SUNDRY NOTICES AND REPORTS ON WELLS

8. Well Name and No.
DAUNTLESS 7 FED 722H

EOG respectfully requests an amendment to our approved APD for this well to reflect changes in the name, casing design & cement, target depth & the addition of a pilot hole.

**** BLM REVISED ** BLM REVISED ** BLM REVISED ** BLM REVISED ** BLM REVISED ****

Lea County, New Mexico
Revised Wellbore Design A 3/5/19

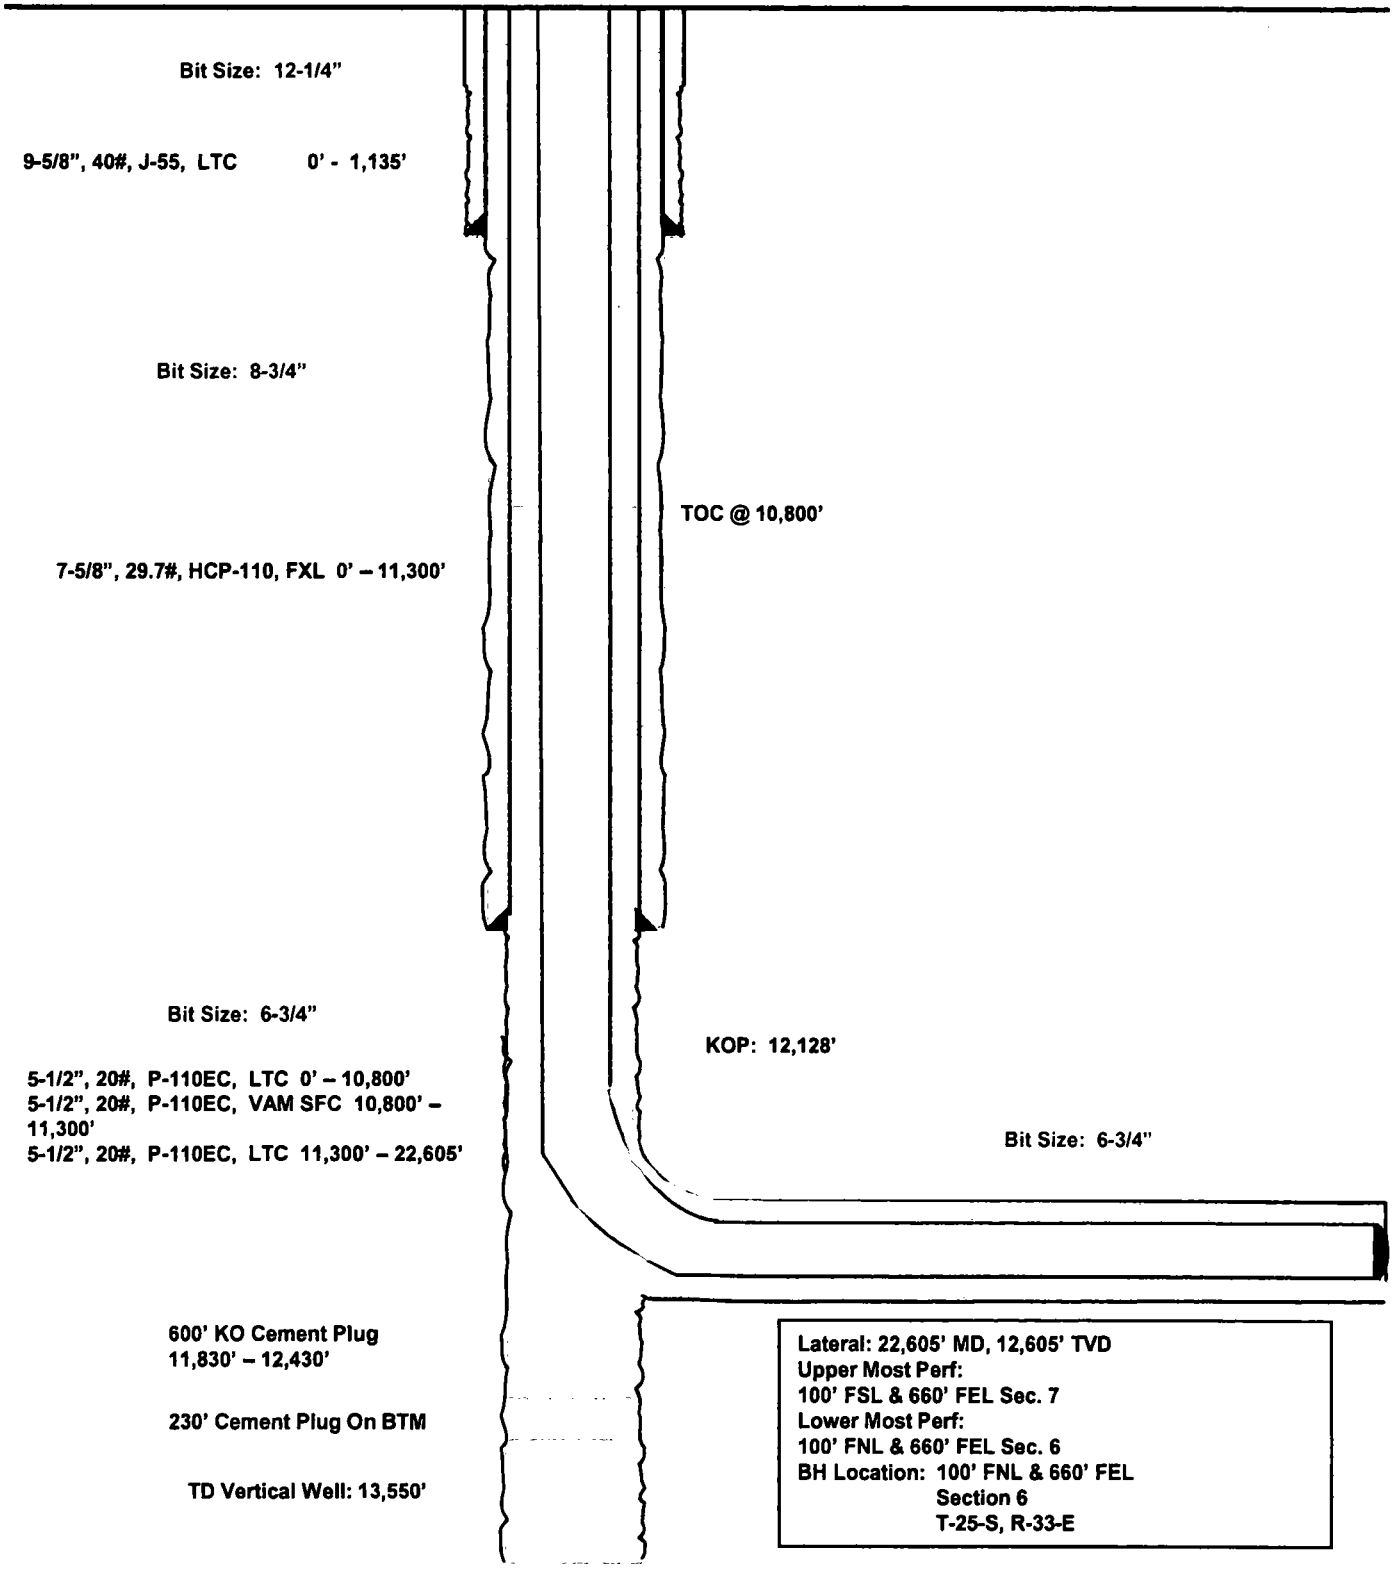
Casing Program:

Hole Size	Interval	Csg OD	Weight	Grade	Conn	DF_{min} Collapse	DF_{min} Burst	DF_{min} Tension
12.25"	0 – 1,135'	9.625"	40#	J-55	LTC	1.125	1.25	1.60
8.75"	0 – 11,300'	7.625"	29.7#	HCP-110	MO-FXL	1.125	1.25	1.60
6.75"	0' – 10,800'	5.5"	20#	P-110EC	LTC	1.125	1.25	1.60
6.75"	10,800' – 11,300'	5.5"	20#	P-110EC	VAM SFC	1.125	1.25	1.60
6.75"	11,300' – 22,605'	5.5"	20#	P-110EC	LTC	1.125	1.25	1.60

Variance is requested to wave the centralizer requirements for the 7-5/8" FJ casing in the 8-3/4" hole size. An expansion additive will be utilized, in the cement slurry, for the entire length of the 8-3/4" hole interval to maximize cement bond and zonal isolation.

Variance is also requested to wave any centralizer requirements for the 5-1/2" FJ casing in the 6-3/4" hole size. An expansion additive will be utilized, in the cement slurry, for the entire length of the 6-3/4" hole interval to maximize cement bond and zonal isolation.

EOG requests variance to allow deviation from the 0.422'' annulus clearance requirement from Onshore Order #2 under the following conditions:

- Annular clearance to meet or exceed 0.422'' between intermediate casing ID and production casing coupling only on the first 500' overlap between both casing strings.
- Annular clearance less than 0.422'' is acceptable for the curve and lateral portions of the production open hole section.

A. CASING

1. The **9-5/8** inch surface casing shall be set at approximately **1,135** feet (a minimum of 25 feet into the Rustler Anhydrite and above the salt) and cemented to the surface.

2. The minimum required fill of cement behind the **7-5/8** inch intermediate casing is:

- Cement to surface. If cement does not circulate see B.1.a, c-d above.

In case of lost circulation, operator has proposed to pump down 9 5/8" X 7 5/8" annulus. Operator must include final fluid top verified by Echo-meter and the volume of displacement fluid above the cement slurry in the annulus. Submit results to the BLM.

3. The minimum required fill of cement behind the **5-1/2** inch production casing is:

- Cement should tie-back at least **200 feet** into the previous casing. Operator shall provide method of verification.

Pilot hole is required to have a plug at the bottom of the hole. If two plugs are set, the BLM is to be contacted (575-393-3612) prior to tag of bottom plug, which must be a minimum of 200' in length. Operator can set one plug from bottom of pilot hole to kick-off point and save the WOC time for tagging the first plug. Note plug tops on subsequent drilling report.

Lea County, New Mexico
Revised Wellbore Design B 3/5/19

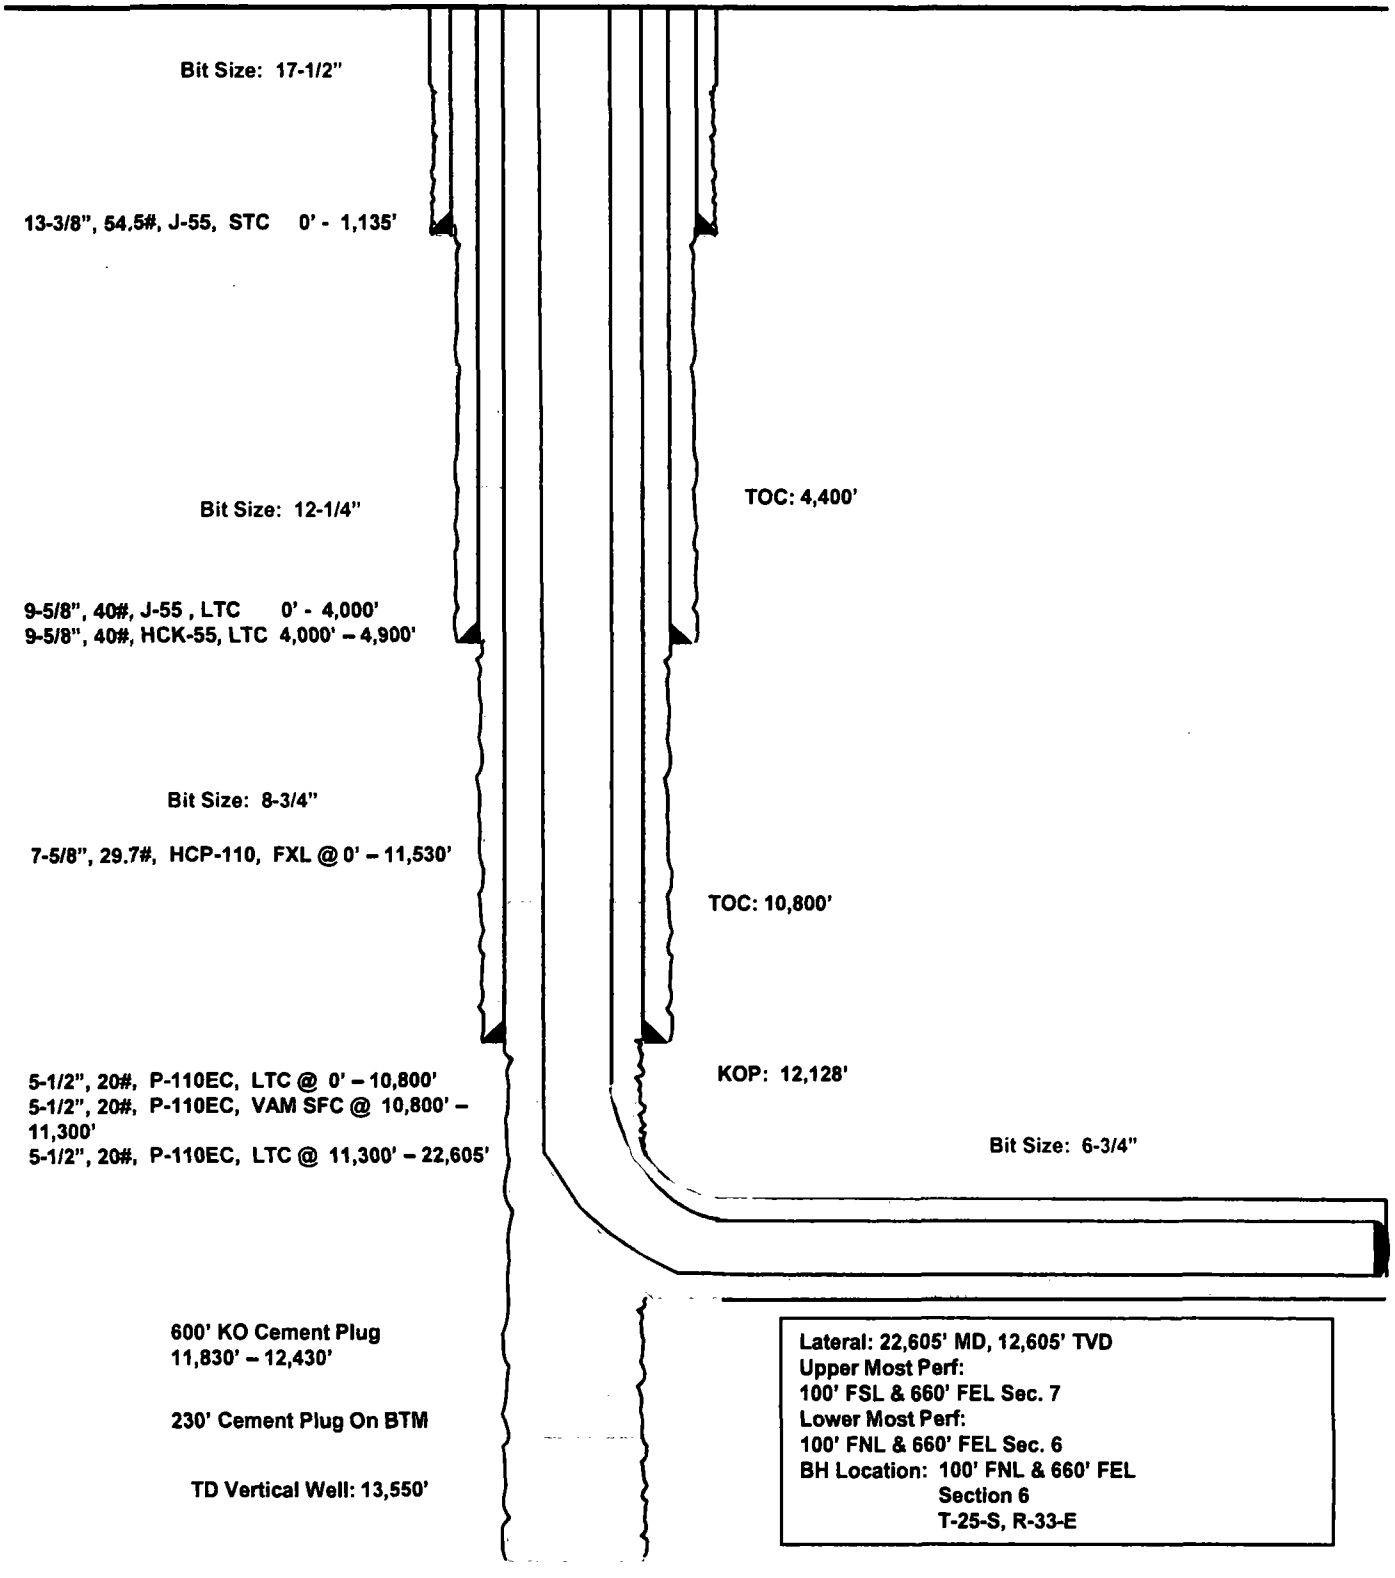
EOG also requests to retain the option to utilize Design B detailed at the end of this document.

Design B

Casing Program:

Hole Size	Interval	Csg OD	Weight	Grade	Conn	DF_{min} Collapse	DF_{min} Burst	DF_{min} Tension
17.5"	0 – 1,135'	13.375"	54.5#	J-55	STC	1.125	1.25	1.60
12.25"	0 – 4,000'	9.625"	40#	J-55	LTC	1.125	1.25	1.60
12.25"	4,000' – 4,900'	9.625"	40#	HCL-80	LTC	1.125	1.25	1.60
8.75"	0 – 11,300'	7.625"	29.7#	HCP-110	FXL	1.125	1.25	1.60
6.75"	0' – 10,800'	5.5"	20#	P-110EC	LTC	1.125	1.25	1.60
6.75"	10,800'–11,300'	5.5"	20#	P-110EC	VAM SFC	1.125	1.25	1.60
6.75"	11,300' – 22,605'	5.5"	20#	P-110EC	LTC	1.125	1.25	1.60

As a contingency, EOG requests to pump a two stage cement job on the 7-5/8'' intermediate casing string with the first stage being pumped conventionally with the calculated top of cement at the Brushy Canyon and the second stage performed as a bradenhead squeeze with planned cement from the Brushy Canyon to surface. If necessary, a top out consisting of 1,000 sacks of Class C cement + 3% Salt + 1% PreMag-M + 6% Bentonite Gel (2.30 yld, 12.91 ppg) will be executed.

Alternate Casing Design (B)

4. The **13-3/8** inch surface casing shall be set at approximately **1,135** feet (a minimum of 25 feet into the Rustler Anhydrite and above the salt) and cemented to the surface.

5. The minimum required fill of cement behind the **9-5/8** inch first intermediate casing is:

- Cement to surface. If cement does not circulate see B.1.a, c-d above.

6. The minimum required fill of cement behind the **7-5/8** inch second intermediate casing is:

- Cement should tie-back at least **200 feet** into the previous casing. Operator shall provide method of verification.

7. The minimum required fill of cement behind the **5-1/2** inch production casing is:

- Cement should tie-back at least **200 feet** into the previous casing. Operator shall provide method of verification.
